Value Engineering Study

East Side Coastal Resiliency Project

April 2018

Preliminary
Value Engineering Study Report
for

Alternative No.: LI-29

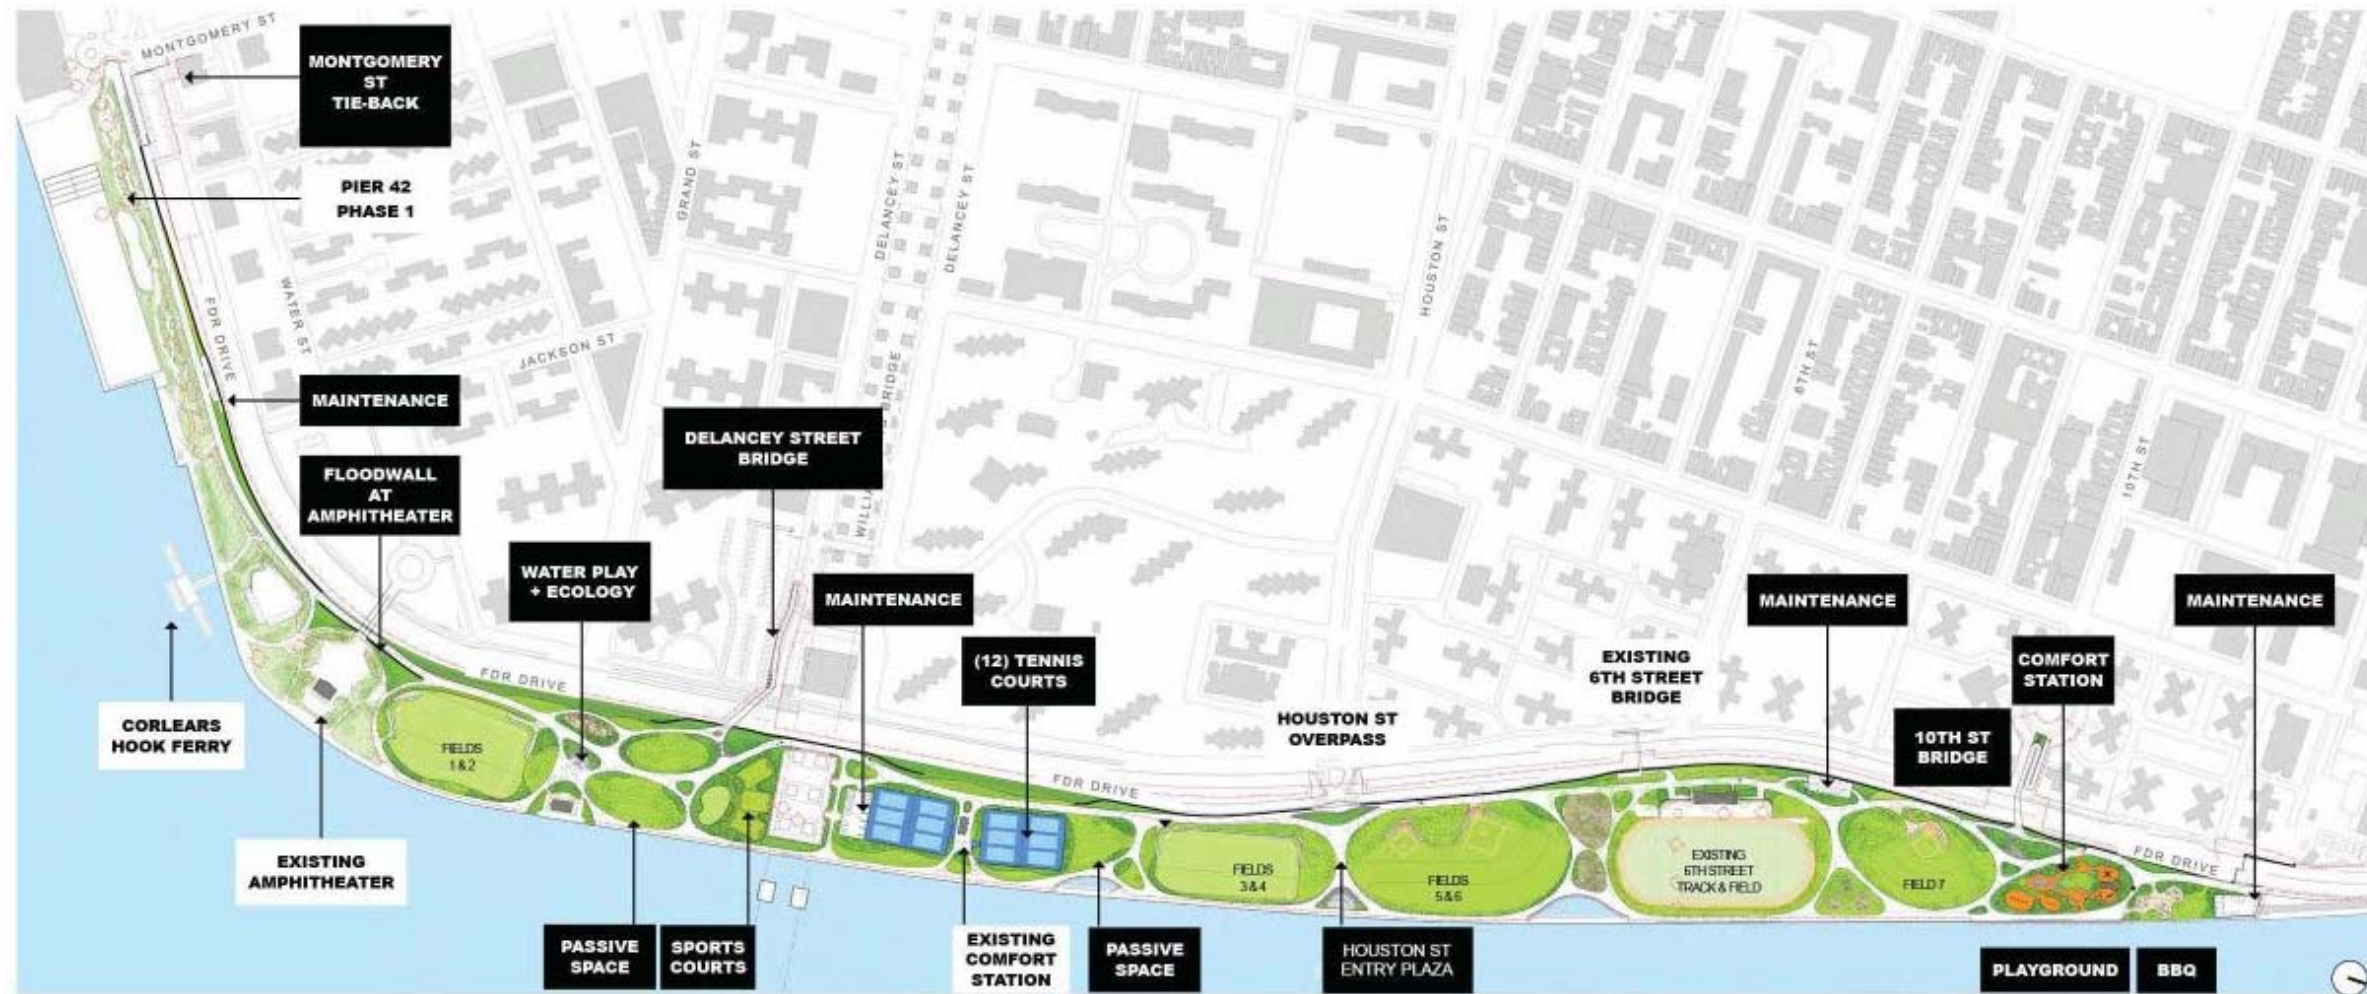
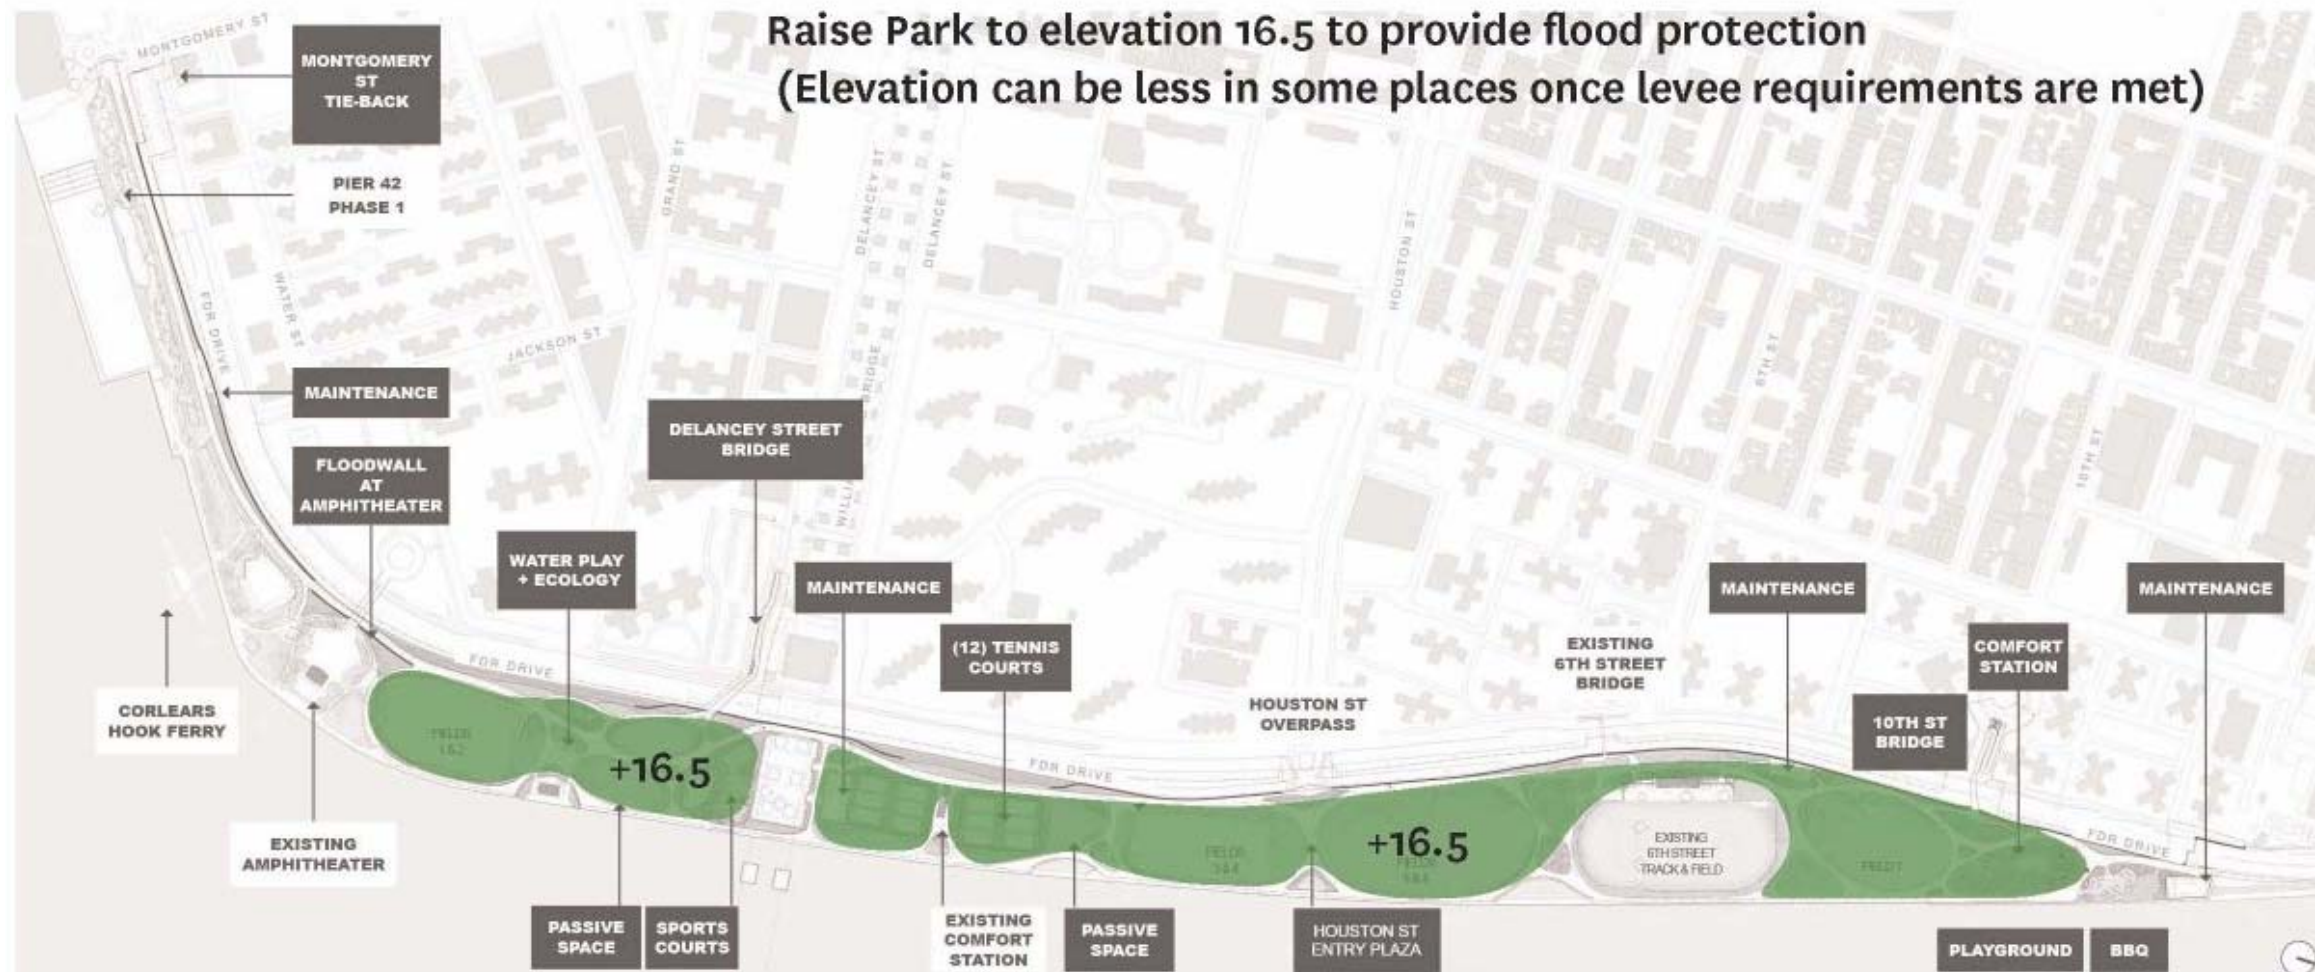
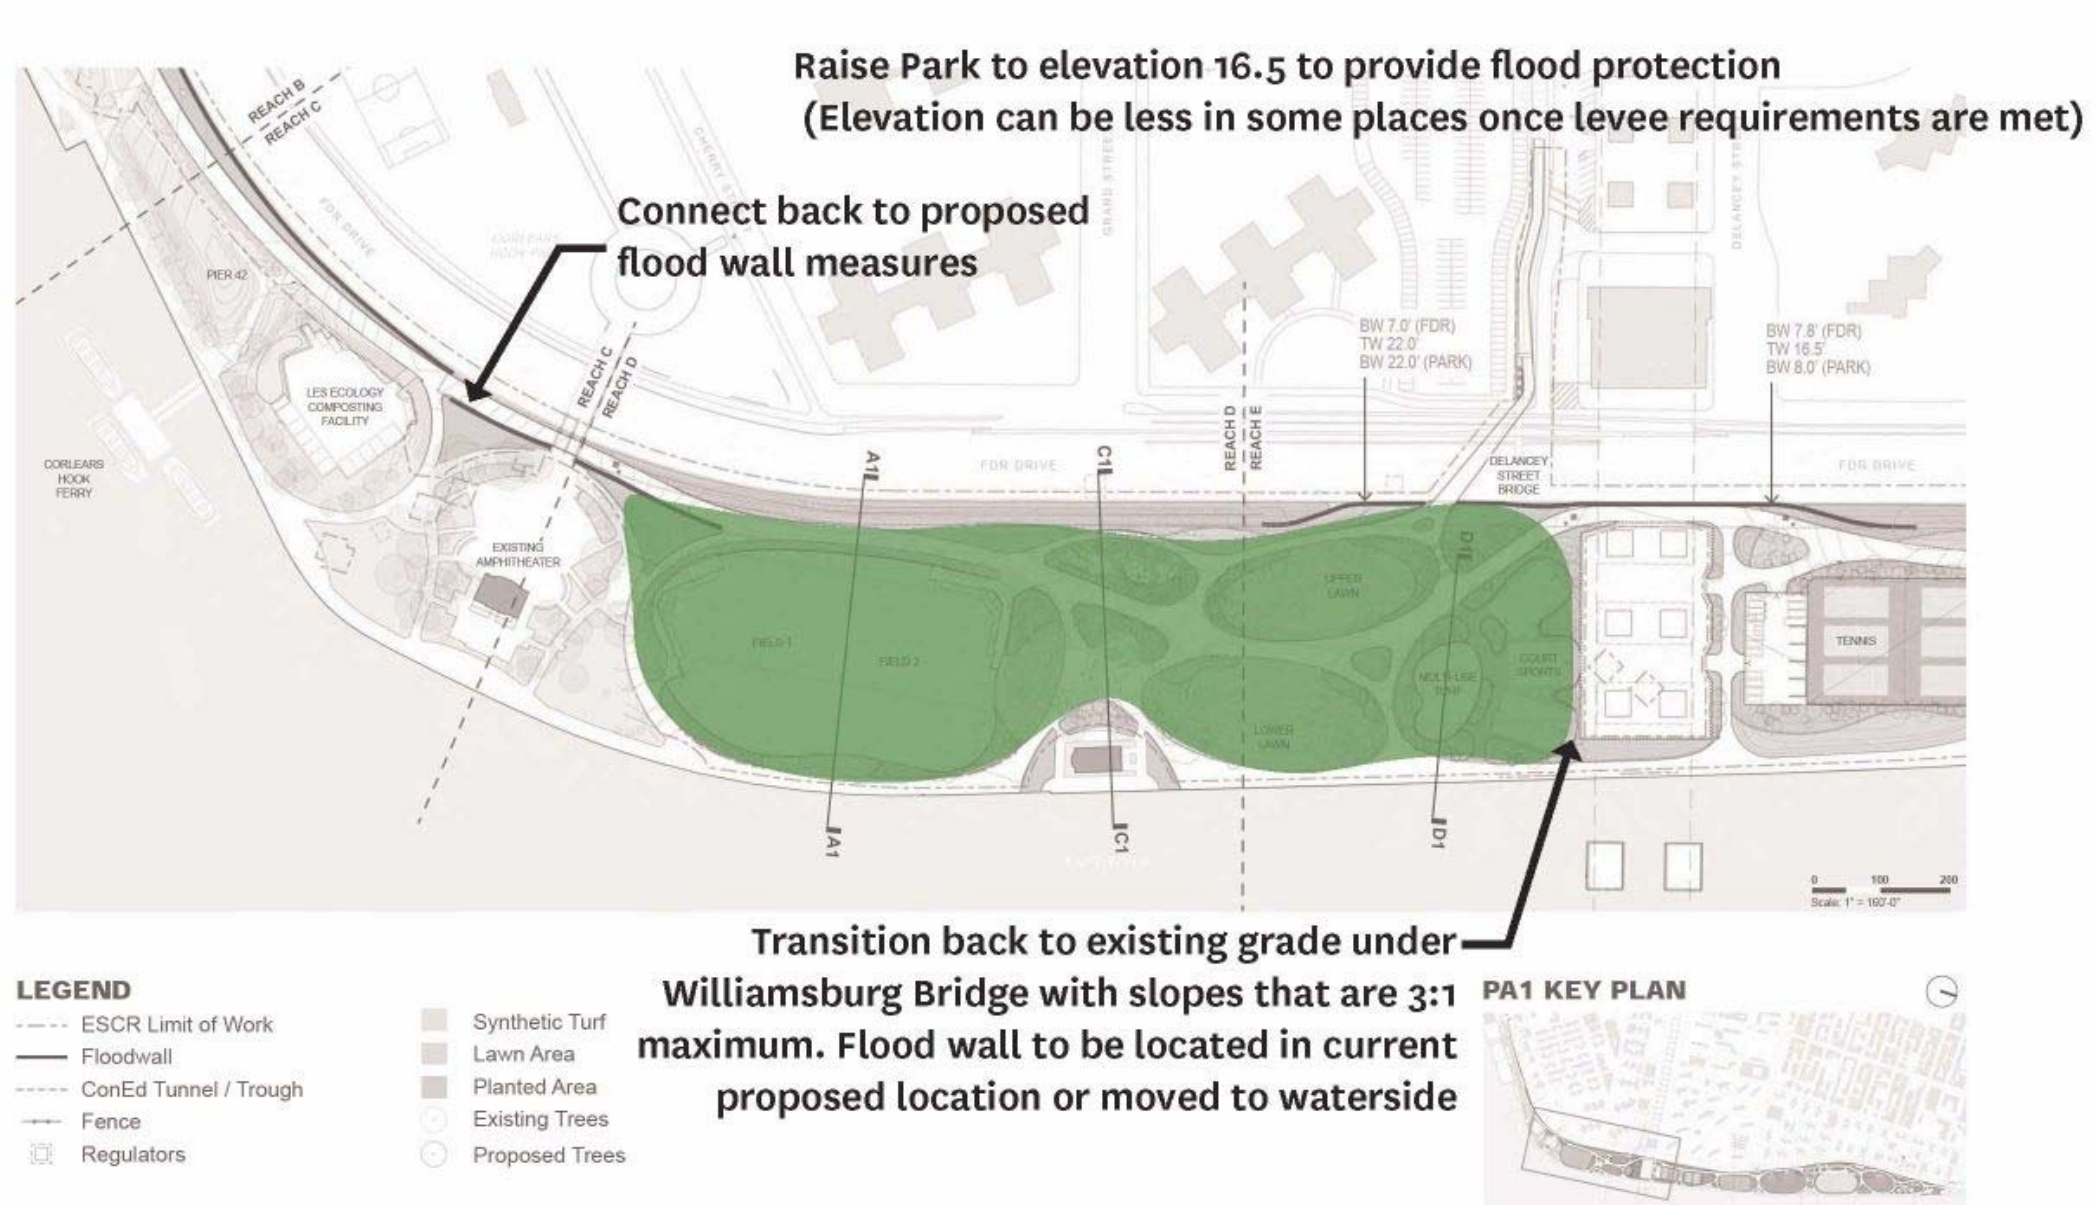
The construction method of placing fill in lifts is a common construction method and should provide a greater bidding competitiveness. The amount of trucks and earth moving will need to be studied from a traffic perspective and staging strategy. Also, the park could be built in a series of phases that would reduce park land alienation and provide the public park land opening in phases instead of being closed all at once.

From a city building perspective, the views will be greater to the City and the East River as well as moving the park up and out of future sea level rise. The raise in elevation should (in most cases) be able to accommodate the current design program reducing any major updates needed for community input. Alterations would be needed to the grading design, and the change will affect many of the design documents, but hopefully the main intent of the design should remain intact.

Alternative No.: LI-30

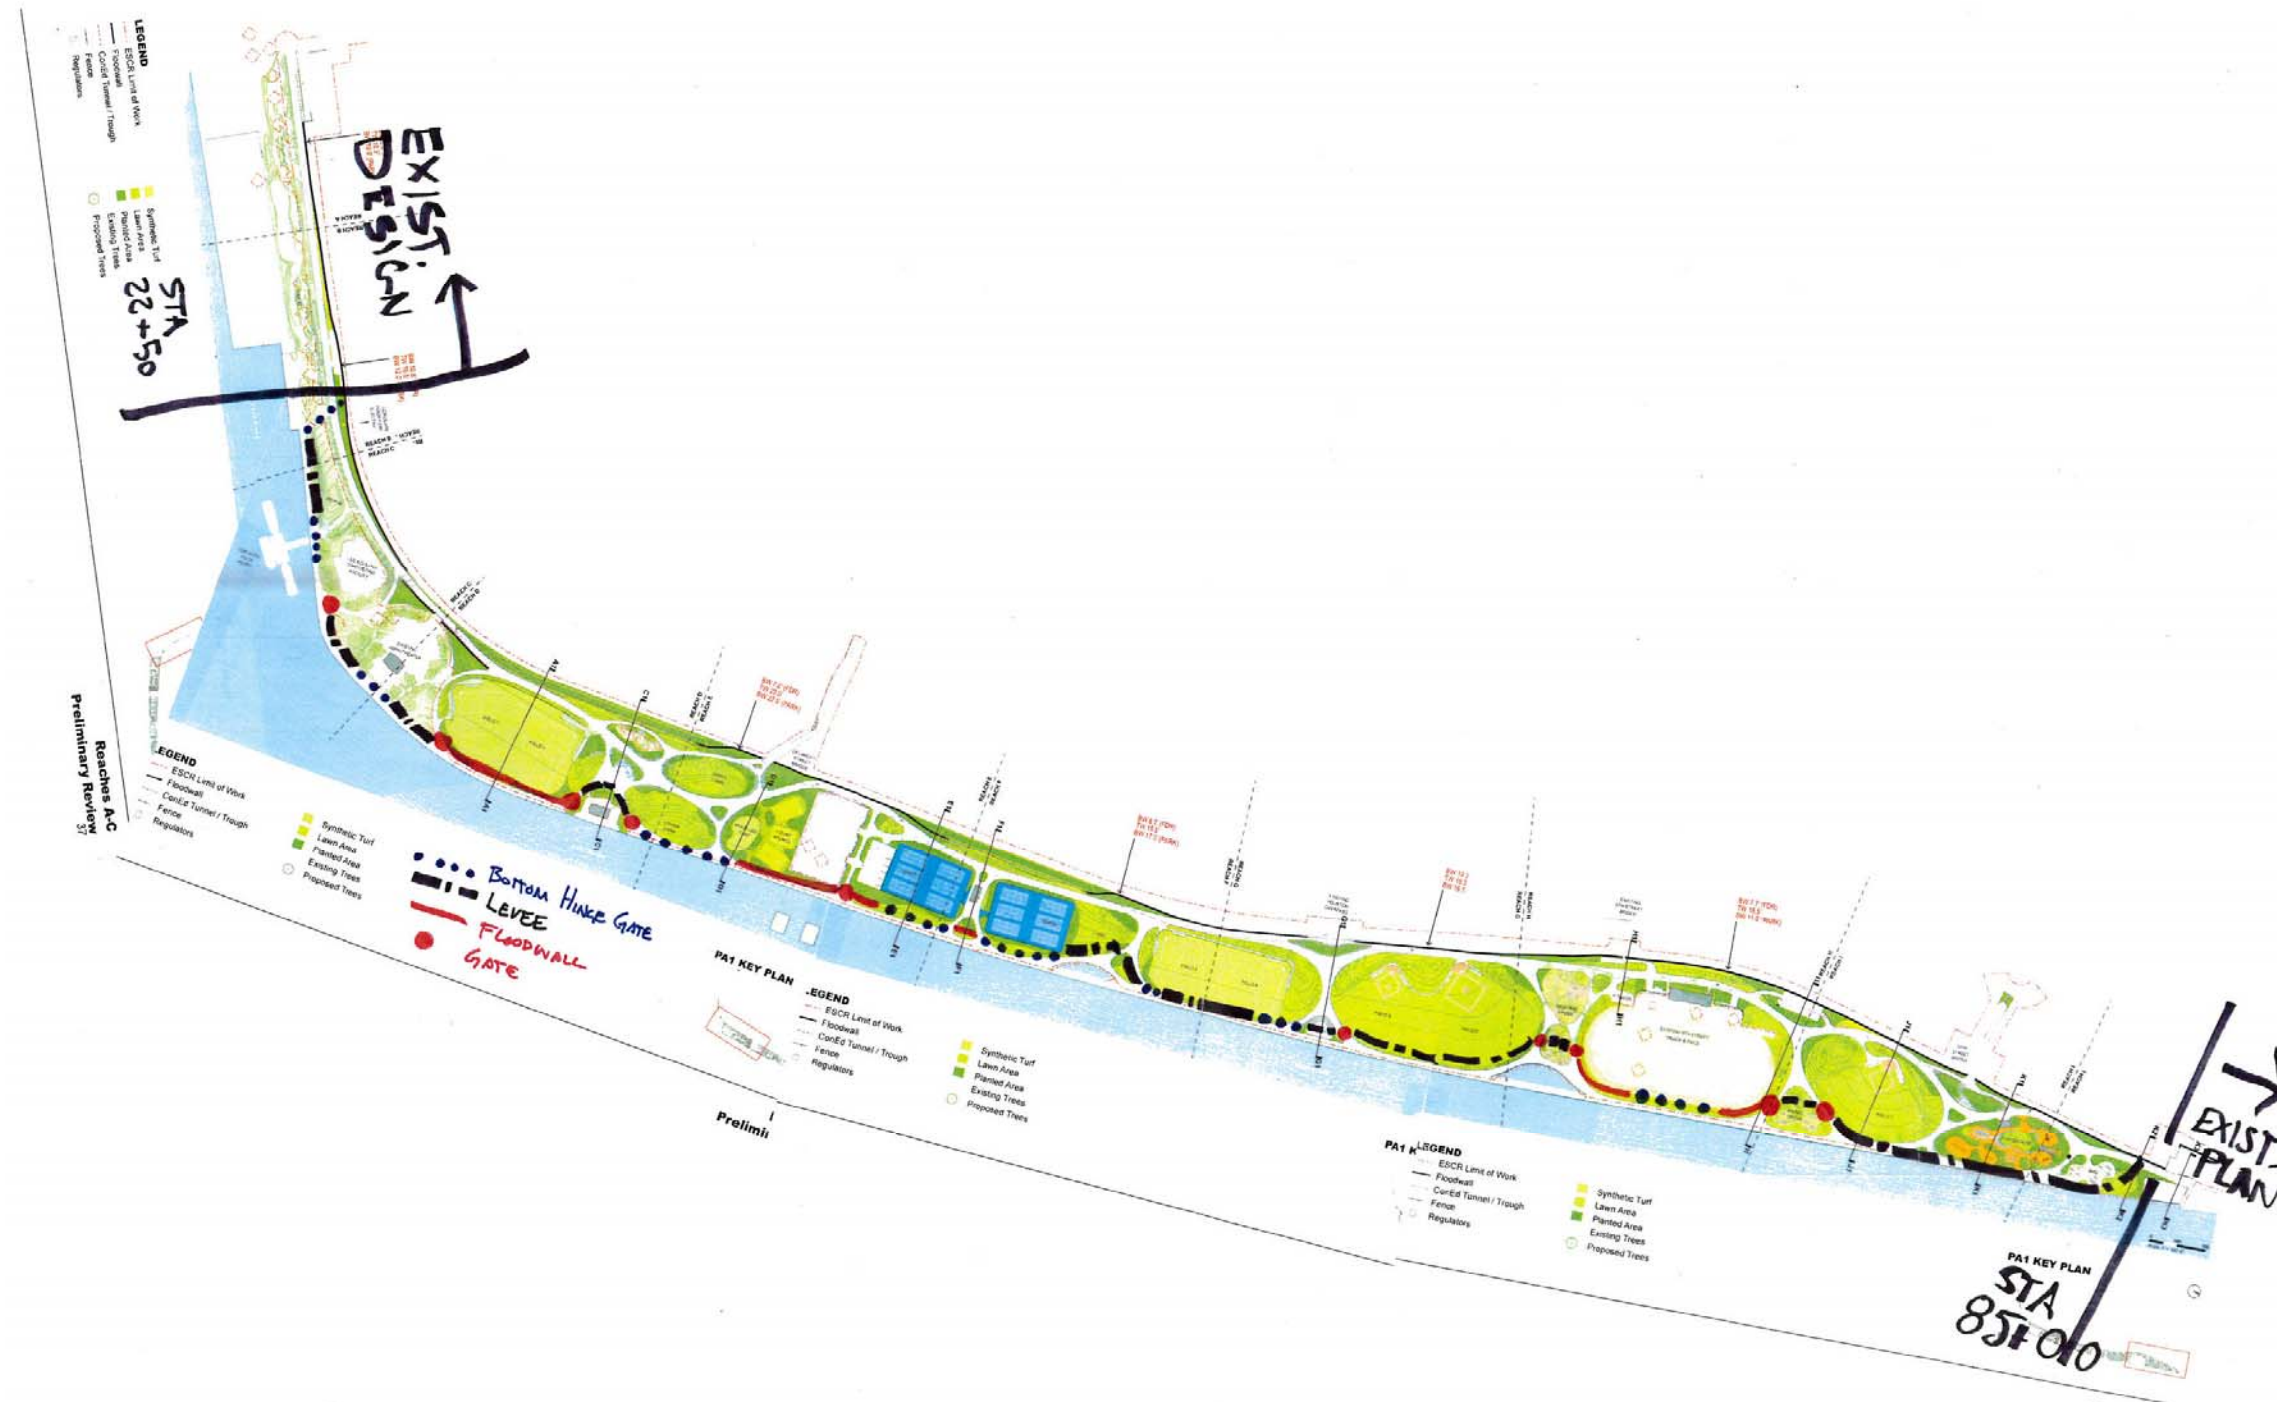
be done by terracing to permit view sheds, raised park areas in limited areas and possible use of transparent or bottom hinged gates that deploy during events.

Design elements and consideration of impacts to the existing EIS will need to be considered.
